2 **7 CONNECTIVITY CONFIGURATIONS.....2**

5 **7.4 Multicast configurations**

7
 8 **Figure 7-23—Multicast ESP in 1/10G-EPON OLT at the OLT to support 10G-**
 9 **EPON and**
 10 **25/50G-EPON ONUs**

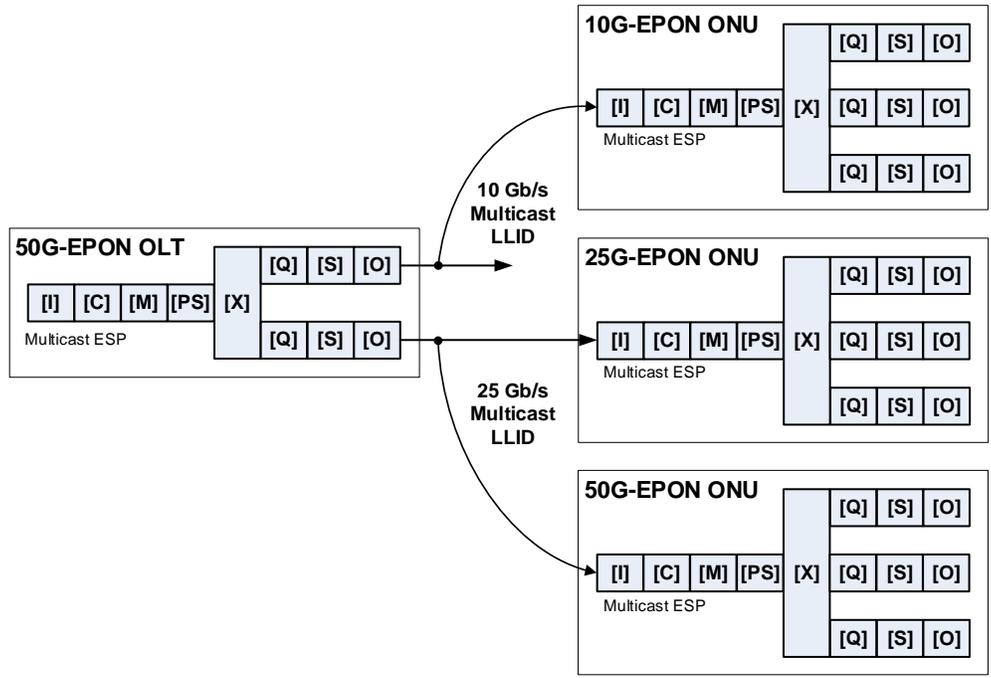
It is also possible to provision multicast ESP at the OLT. This It may be necessary to provision a multicast ESP at the OLT in several situations, e.g., in a situation when a multicast group combines an OLT operates at both 10 Gb/s ONUs and with 40-25 Gb/s and/or 50 Gb/s ONUs downstream line rates as when 25G-EPON and 50G-EPON coexist on the same outside plant (see). In this case, the CrossConnect at the OLT may be provisioned to duplicate each multicast frame to 10G-EPON and 25G-EPON and 50G-EPON SCB P2MP logical linkchannels (see Figure 7-23). The 50 Gb/s ONUs may receive multicast traffic on a 25 Gb/s P2MP logical link together with 25 Gb/s ONUs, or on a separate 50 Gb/s P2MP logical link (see 7.4.2.3).

1 is limited to 25 Gb/s, even for the 50G-EPON ONUs that are able to receive at the rate of 50 Gb/s. This
2 method is illustrated in Figure 7-23.

3 The other method to combine 25 Gb/s ONUs and 50 Gb/s ONUs into a single multicast group is to allocate
4 separate P2MP logical links for the 25 Gb/s ONUs and 50 Gb/s ONUs. In this method, a multicast ESP at
5 the OLT duplicates multicast frames into two separate logical links: one transmitting only to 25 Gb/s ONUs,
6 and the other transmitting only to 50 Gb/s ONUs. This method uses different mLLID values for 25 Gb/s
7 ONUs and 50 Gb/s ONUs. The mLLID that is provisioned for the 50 Gb/s ONUs is able to transmit data at
8 a rate of 50 Gb/s. This method is illustrated in Figure 7-23.

Figure 7-24—Multicast connectivity without inter-ONU multicast

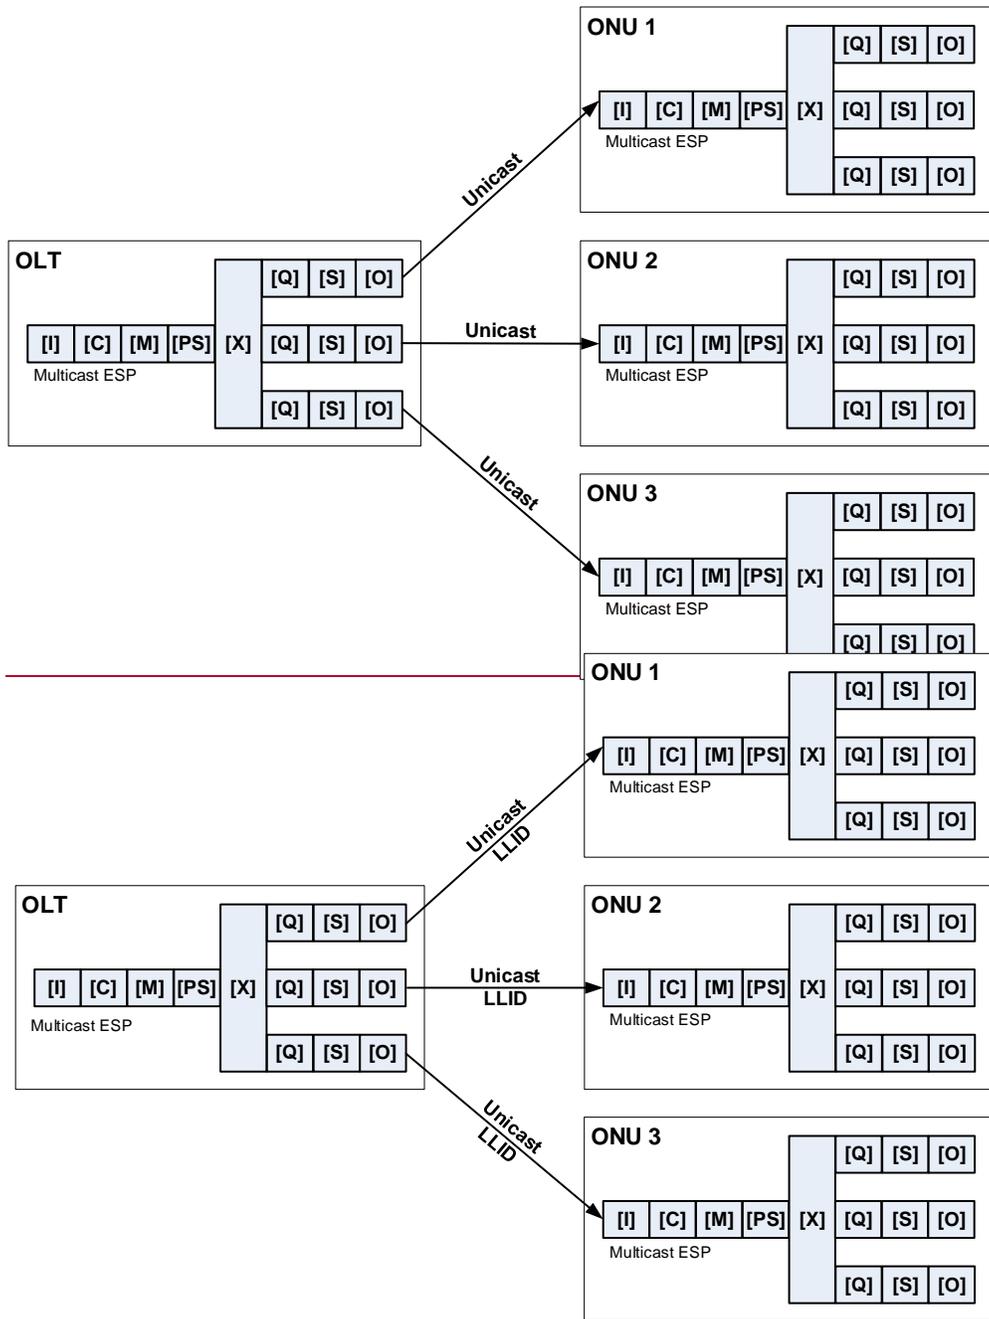
1 It is also possible to use multicast ESP at the OLT in order to eliminate inter-ONU multicast. In this case,
 2 EPON multicast connectivity is achieved by duplicating each multicast frame at the OLT into multiple
 3 queues and delivering a separate copy of the frame to each ONU using previously established P2P logical
 4 links, as shown in Figure 7-24. This method allows independent encryption of each ONU's traffic (including
 5 the multicast traffic), however it consumes more downstream bandwidth than the single-copy multicast
 6 method utilizing the mLLD.

11 ~~It is also possible to use multicast ESP at the OLT in order to eliminate inter-ONU multicast. In this case,~~
 12 ~~EPON multicast connectivity is achieved by duplicating each multicast frame at the OLT into multiple~~
 13 ~~queues and delivering a separate copy of the frame to each ONU using previously established unicast~~
 14 ~~channels, as shown in Figure 7-24.~~
